Ms. Elaine Brummert  
U.S. Nuclear Regulatory Commission  
Fuel Cycle Facilities Branch  
Division of Fuel Cycle Safety and Safeguards  
Office of Nuclear Material Safety and Safetyguards

Re: Responses to Cabot Corporation Request for Additional Information, Renewal of  
NRC Source Material License SM-920

**Figure 1. Wind Direction as a percentage of total time with wind.**

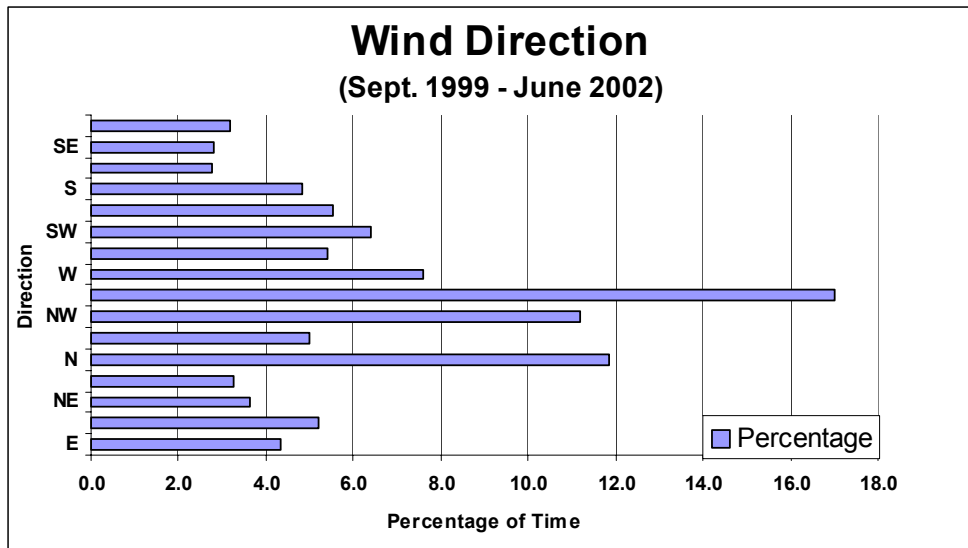
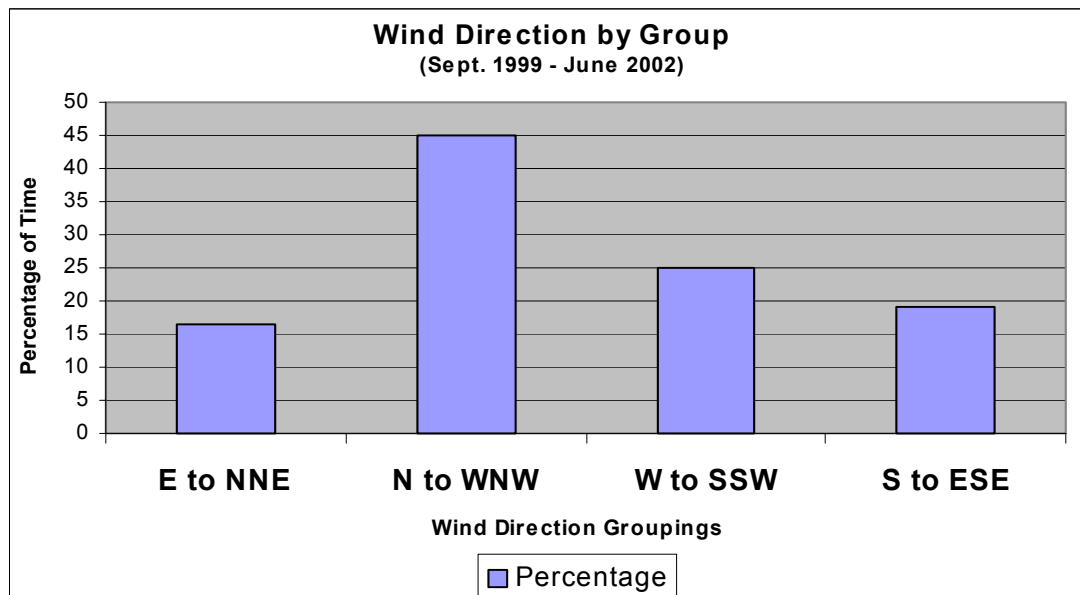
*2. **Climatology and Meteorology.** The licensee should provide updated climatology and meteorology data for the site area.*

*The climatology and meteorology data described in the ER for the 1994-1996 license renewal accounts for the time period between the years 1972 and 1976. The staff considers this time interval to be of limited value in evaluating the potential impacts of site activities under various climatic conditions (e.g., tornados).*

Wind direction data were recorded in hourly increments. Calm wind speed (which resulted in a non-detectable wind direction) was observed approximately 30% of the total

observed time. The remaining 70% of observed wind directions are shown as the total detectable wind direction observations, as shown in Figures 1 and 2. The predominant wind direction group was north to west-northwest, which was observed 45% of the observed time.

Figure 3. Average ambient air fluoride concentrations.

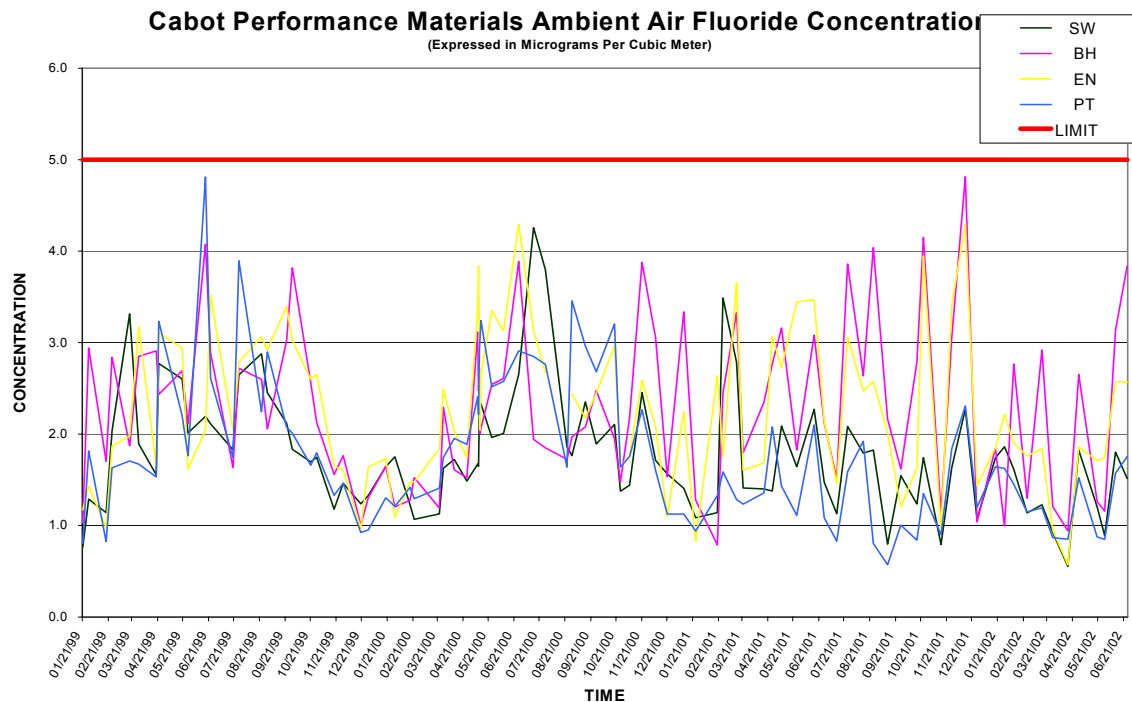
- a. *The licensee should provide updated ER information regarding: (1) Air Monitoring, (2) Forage Sampling, (3) Surface Water and Sediment Sampling, and (4) Groundwater Monitoring. The licensee should provide tabulated data or summary graphs for the monitoring results mentioned above and required under License Condition 14. The licensee should include the monitoring evaluation such as the possible effects of the nonradiological constituents released to the environment by the facility. For example, the staff considers that the licensee's proposal to discontinue the monitoring of the forage crops for fluoride should be justified (based on releases 1996-2001) because fluoride could have an impact on the biotic resources. Also, the licensee should provide data on any evaluation since June 2001, for the elevated radiation in the MMW3 monitoring well.*

- b. *The staff considers that changes or trends in monitoring data may have occurred in the last 6 years that staff should consider for the EA. The 1996 EA indicated that the operation of the facility had resulted in elevated fluoride concentration in forage crops growing adjacent to the plant, and the biannual monitoring of both the corn and the grasses since 1988 indicated that the annual average fluoride concentration has exceeded the 40 parts per million reporting level required by the previous license for reporting results to the Pennsylvania Department of Environmental Resources and the NRC. Also, the Cabot RSO report of June 29, 2001, indicated possible reasons for elevated radiation in the MMW3 monitoring well but the effects should have dissipated by this time and possibly another source of the contamination identified.*

The results of the environmental monitoring for fluoride are summarized in Figure 3 for the period 1999 through 2002. During this time period there have been no excursions that have exceeded the Commonwealth of Pennsylvania fluoride standard of 5  $\mu\text{g}/\text{m}^3$ .
